# **Westinghouse PWR/BWR Fuel Packages**

**Amendment Request  
Schedule Review**

June 22, 2010

# Clamshell Top End Plate

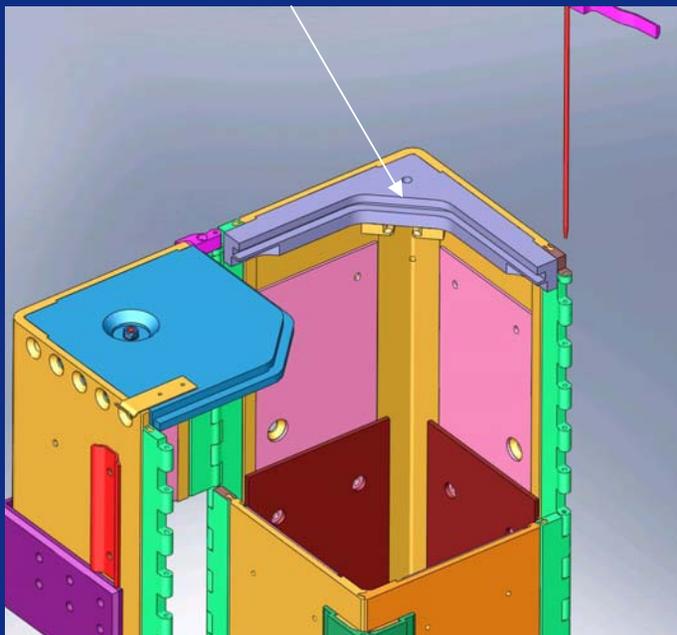
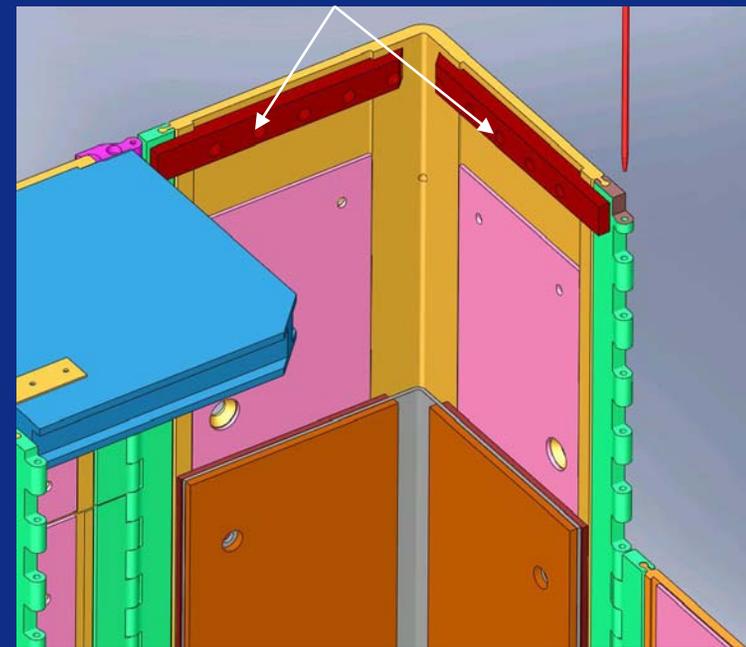
Shear lip interferes with nuclear power plant fuel tools

Current Top Plate

New design has equal shear but increase envelope for all plant fuel tools

Top plate design change
